PRODUCT CHANGE NOTIFICATION

Bourns® Model SRF1260A and SRF1280A Series Dual-Winding Shielded Power Inductors

Gluing Process Changes

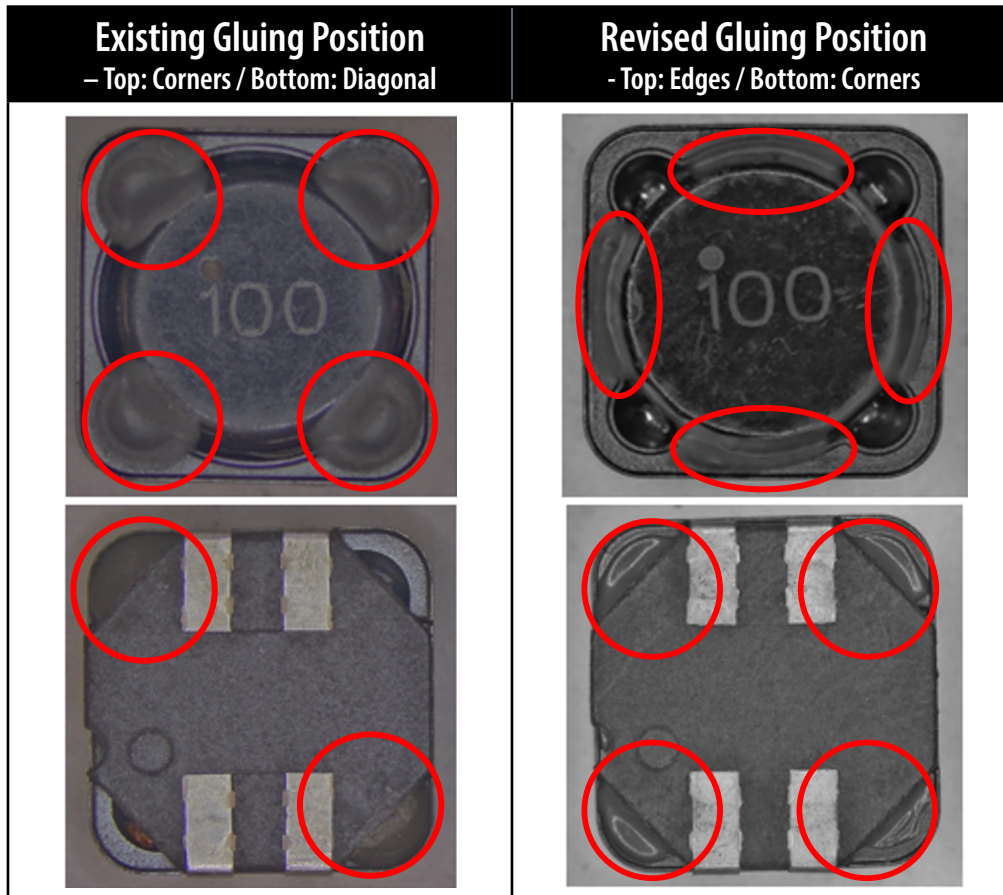
Riverside, California – June 17, 2024 – In the spirit of continuous improvement, effective February 28, 2025, Bourns will change the gluing process from a manual to an automated process for the Model [SRF1260A](#) and [SRF1280A](#) Series Dual-Winding Shielded Power Inductors. Additionally, the type of glue and its application position will be changed to enhance durability. A list of affected part numbers is included below.

As shown in the images above, the form of the affected part numbers will change slightly due to the change in gluing position. The fit and function of the affected inductors will remain the same. The quality and reliability of the affected inductors should be improved as a result of the changes. Traceability will be maintained through lot code and date code.
